**Environmental Assessment of Ground Water Compliance
at the Gunnison, Colorado, UMTRA Project Site**

Final

SUBJECT: NATIONAL PARK SERVICE RESPONSE TO DRAFT ENVIRONMENTAL
ASSESSMENT OF GROUND WATER COMPLIANCE AT THE GUNNISON, COLORADO,
UMTRA PROJECT SITE WORK PLAN AND GUNNISON PUBLIC MEETING

**Response to Comments from the National Park Service (NPS)
on the Gunnison, Colorado, UMTRA Project Site
in a Letter to DOE Dated April 10, 2002**

Simulated Water Levels - Layer 7

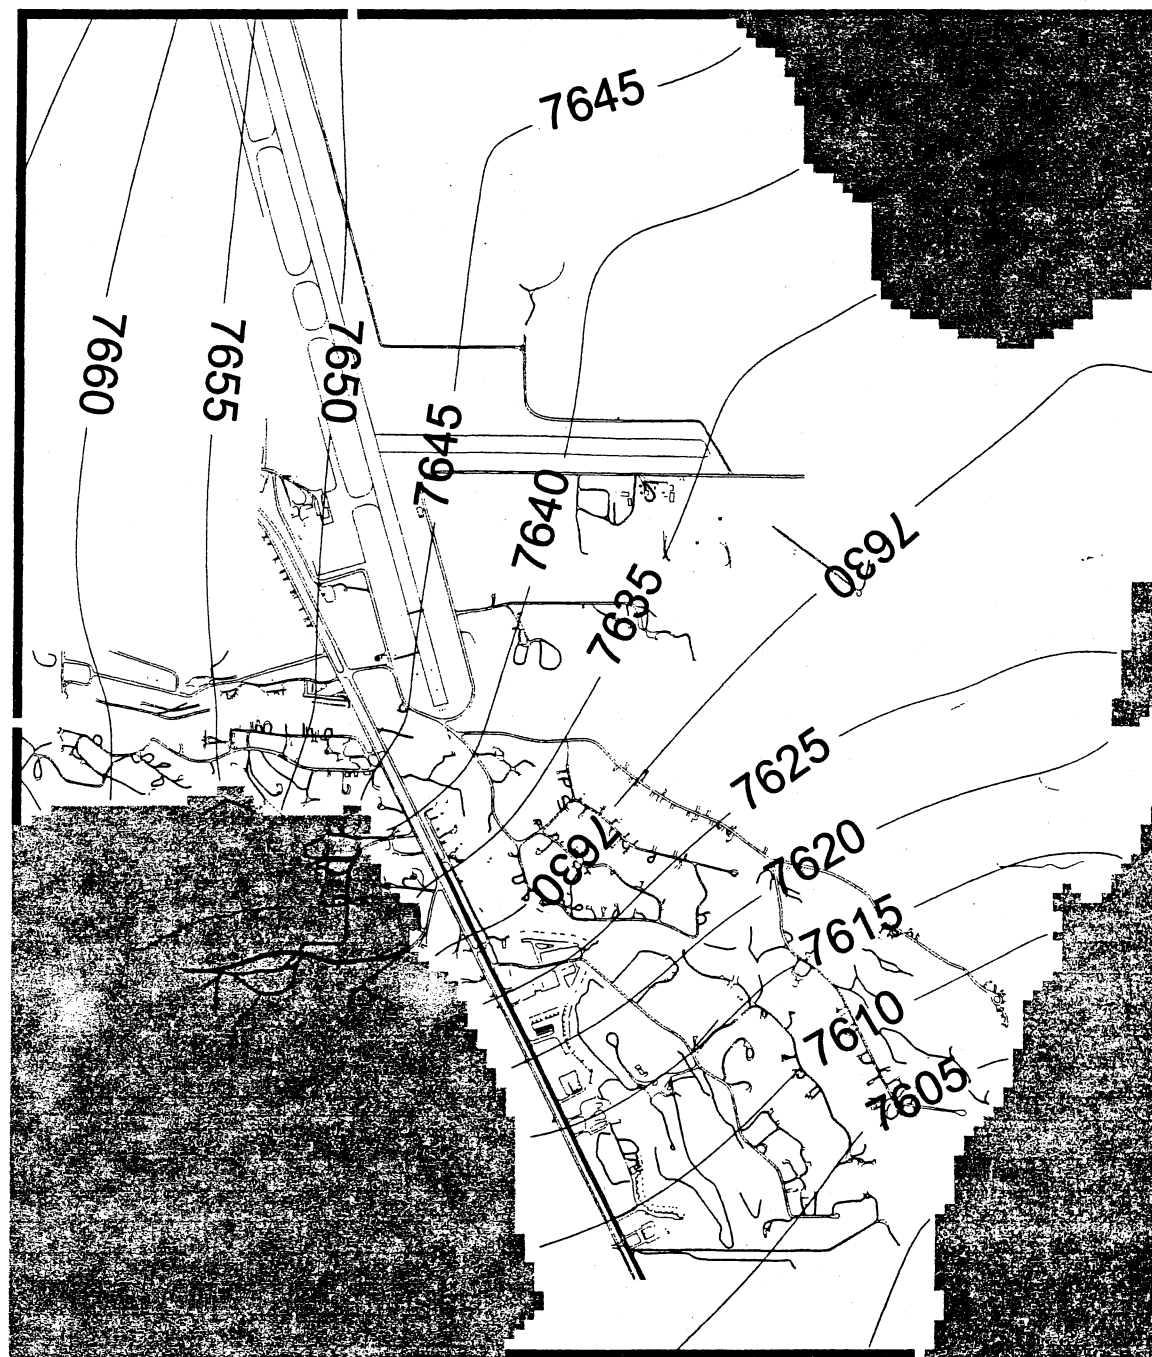
- 1) Flow Modeling: The *Work Plan* presents field and modeled water level for only the intermediate zone. Please show field and modeled water levels for the shallow zone, and for layer 3. In addition, please show or discuss the values used for the starting heads in the shallow aquifer.

Response: The initial water level (starting heads) used for all seven layers was 7620 feet. This is an average value in the middle of the site. The model was run with these as starting heads to get a final head solution. The final head solution for simulation #1 then becomes the initial head for simulation #2. This substitution of final head from simulation n for initial head for simulation $n+1$ continues until the simulation converges within a few iterations (less than 10) and the simulated drawdown is essentially zero everywhere. Plots of simulated water level are attached for all seven layers.
